Revision	Description	Date
A	Initial Release	?
B	As built changes: E990211-00-C	5/99
C	1. Added compensation networks to coil drivers with capacitors, Cadd1 through Cadd10 and resistors Radd1 through Radd5 2. Changed coil driver 183 ohm (R202, R216, R229, R243, R256) to 125 ohm, 2 Watt for ITMX and ITMY and to 183 ohm 1 watt on all other chassis. 3. Cadd1 through Cadd14 added to board to stabilize and limit high freq gain of 1Hz zero, 40Hz pole compensation stage. 4. Dadd1 through Dadd20 added to coil driver for op amp input protection.	2/00
D	Added Radd6, Radd7, Radd8, Radd9 to terminate unused inputs of MAX333 switches per E010178-00.	10/01
D1	Removed two stages of chebychev filter for each degree of freedom per E010181-00.	10/01
D2	Added note (sheet 1) about replacement of input matrix MAX509s with fixed resistors per E010184-00.	10/01

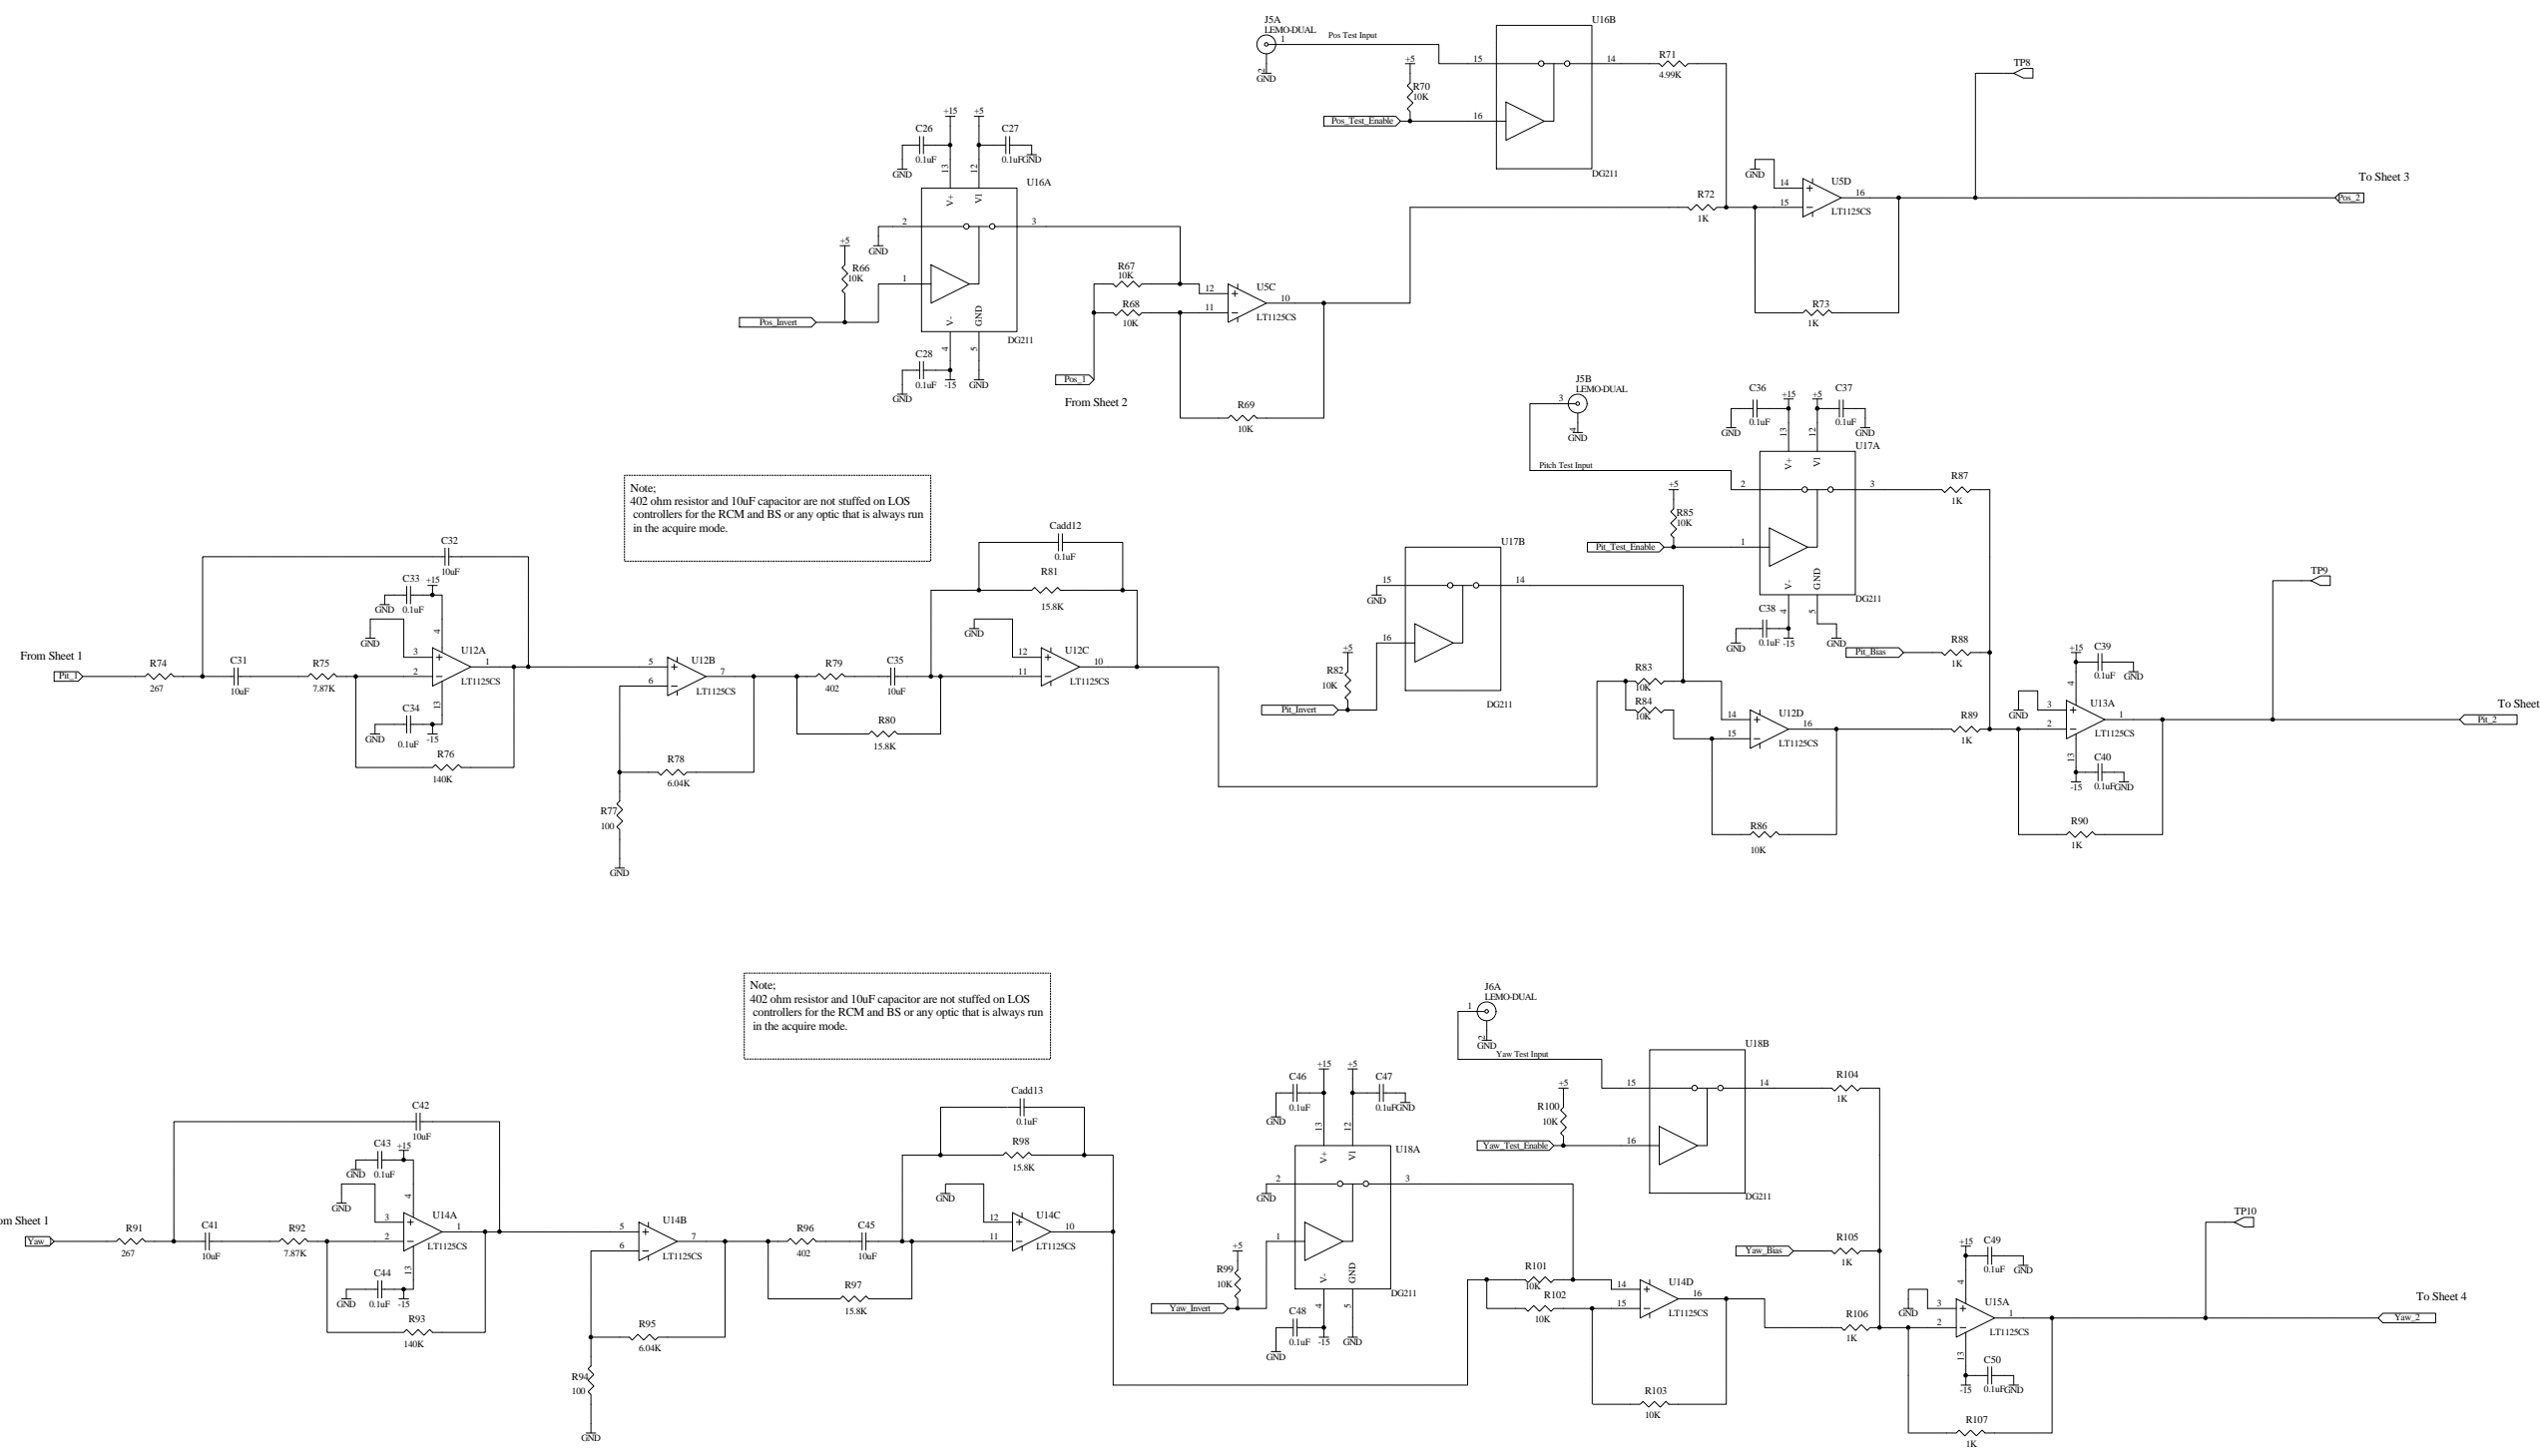
Rev D2 Upgrade
 Note: In some cases the input MAX929s have been replaced by fixed resistors. The MAX929 is removed and the resistor placed from the input pin to the output pin. If a fixed pot value of 25% is needed the fixed resistor will be a 3K ohm resistor.

Note: 402 ohm resistor and 10uF capacitor are not stuffed on LOS controllers for the RCM and BS or any optic that is always run in the acquire mode.
